Review and Preliminary Assessment of the
Permit Application Materials for a
Proposed Zinc- and Copper-Sulfide Mine
near Crandon, Wisconsin

Environmental Law & Policy Center
35 E Wacker Drive, Suite 1300
Chicago IL 60601-2208

December, 1997

Date: February 5, 1998
To: Caryl Terrell, Legislative Coordinator-Sierra Club John Muir Chapter
From: Dave Blouin, Mining committee chair
Re: Revision of Chapter NR 182-Order SW-21-97 (B)

Groundwater Permitting Criteria for Mines and Mining Waste Facilities

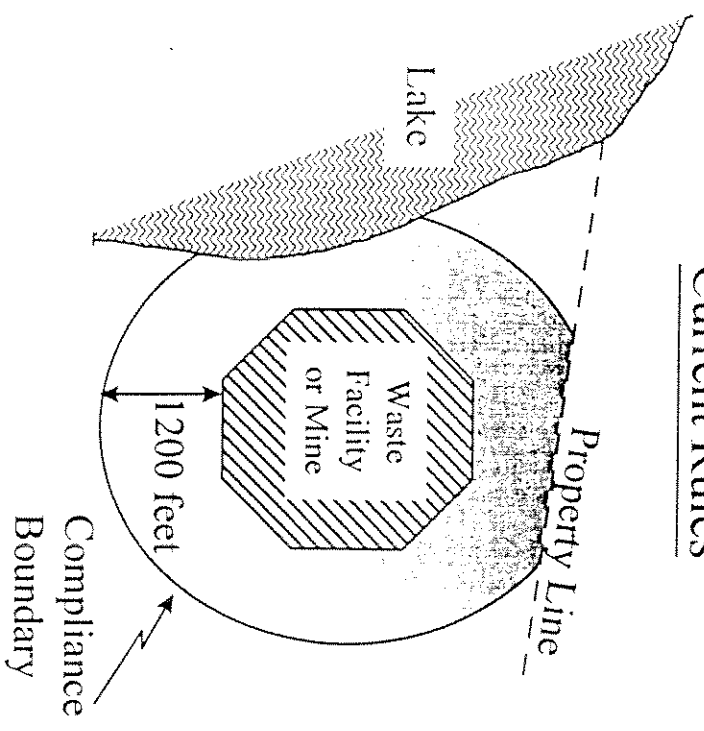
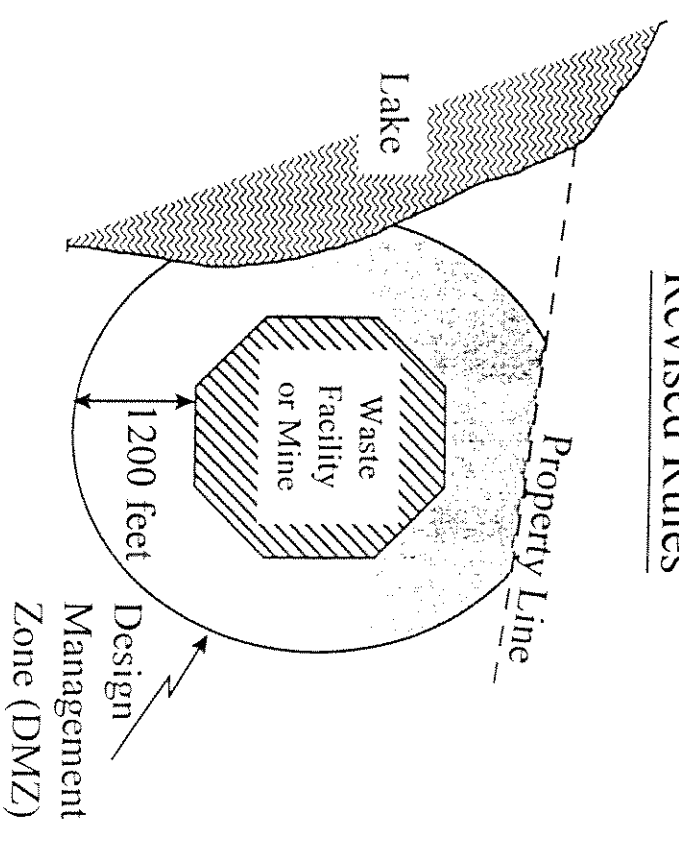
-petition by legislators to evaluate how groundwater quality is regulated at mining sites.
-public concerns about drawdown, chemical transport and extensive pollution zone/DMZ
-handout -- diagram from DNR rule package -- large area in DMZ/pollution zone and no real change from existing rule, just name changes

This rule places all groundwater protection in one basket--modeling. We can do better than that. Monitoring at the edge of the waste and edge of the facility will provide valuable information to protect groundwater. DNR should use modeling and monitoring.

The proposed rule takes several steps backward. We urge this committee to reject this rule or alternatively direct DNR to make the following changes: make DMZ zero feet (the same as other new hazardous waste facilities) and remove the waiver provision.
